From: Emily Wade <Emily.Wade@midsussex.gov.uk>
Sent: 20 March 2026 17:29:18 UTC+01:00
To: "Tracie Axford" <Tracie.Axford@midsussex.gov.uk>
Subject: DM/26/0007 Oakley Lodge, 13 High Street, Lindfield

The application site is one half of a late 19th/early 20th century handed villa pair located within the Lindfield Conservation Area. The current proposal is for a single storey extension to the rear of the house, taking in an existing single storey addition sitting against the boundary with the attached neighbour, and wrapping around the base of the original two storey rear wing.

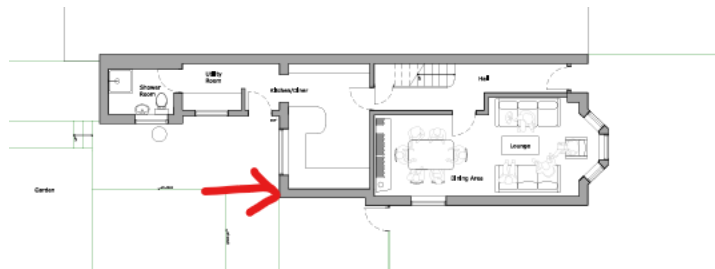
In this context, the principle of a rear extension is not considered contentious. I do however have some concerns regarding the footprint of the addition in terms of its width, in that this is shown projecting beyond the side elevation of the original house. In my opinion this will not be acceptable, as the extension will not as result read as appropriately subservient to the host dwelling, and will also be visible in public views along the side of the house from the High Street. The width of the addition should be reduced so that it sits no further to the southwest than the line of the side elevation to the original building where this steps in from the main front range (see red arrow below).

In summary, while the principle of the proposal and the design approach are considered acceptable, the scale of the addition and in particular its width require amendment to ensure that the character and appearance of the Conservation Area are preserved, meeting the requirements of District Plan Policy DP35, the Council's adopted Design Guide and the relevant paragraphs of the NPPF.
